FLOOD DESIGN REPORT

A2I | Albury to Illabo

Package: A2I – Table Top Yard

5-0052-210-IHY-B6-RP-0001

Figure 6-5: 1% AEP Flood Depth Extent – Reporting Locations

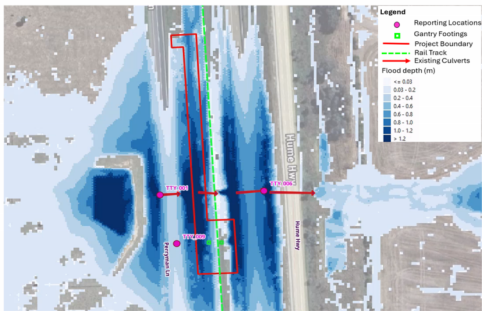
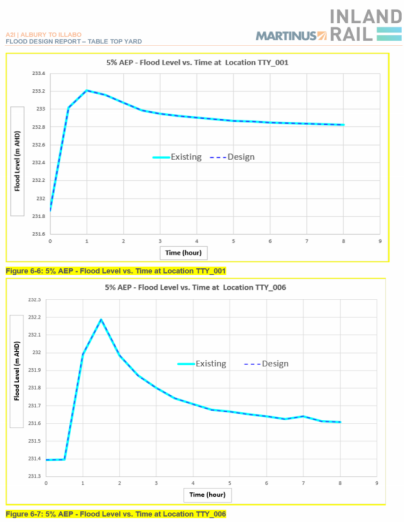
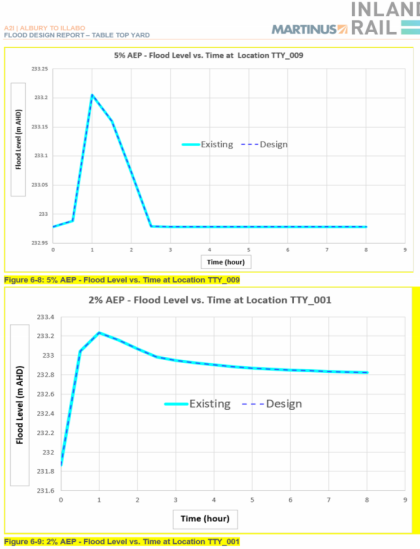
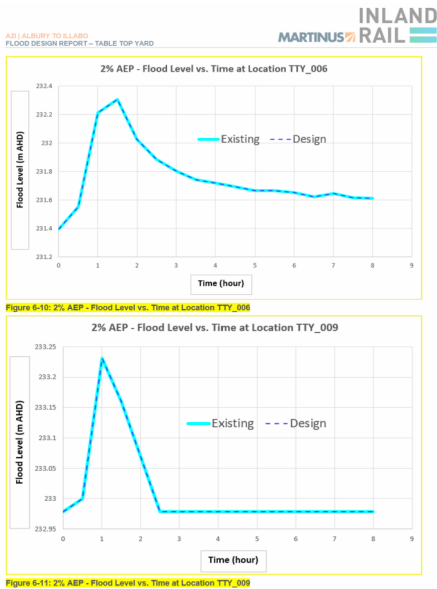
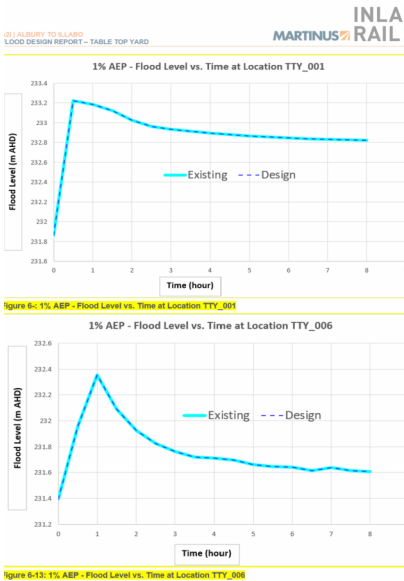
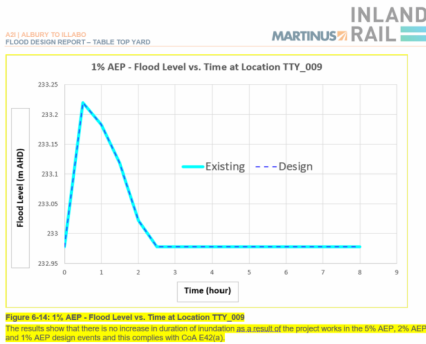
1	CoA E42		5-0052-210-IHY-B6-RP-0001_A.pdf		Page 28, 5-0052-210-IHY-B6-RP-0001_A, Section 6.4.4		DDR		Flow is not an appropriate parameter for comparing inundation time at a location. Please utilise water level instead of flow.		Non-Compliant		Ayub Ali		3/03/2025		Yucen Lu		DJV Flood Modeller		10/03/2025		The flood level comparison has been added to represent the changes in duration of inundation (yellow highlight in the screenshot below)		Section 6.4.4 of 5-0052-210-IHY-B6-RP-0001		Ayub Ali		18/03/2025		CLOSED		If's a time series, not peak level. Hence, replace the term "peak flood levels" with just "flood levels". This item can be closed once it is corrected. Ayub confirmed sighting evidence change 20/3/25	
2																																		
3																																		
4																																		
							Non-Compliant: Non-compliance which requires correction before further design development occurs.																	OPEN: Comment has not been addressed.

There are no changes in duration inundations as there is no change in peak flood levels, peak flood velocities and peak flood hazard. The flood levels comparison between existing and design at the reporting locations are shown as below
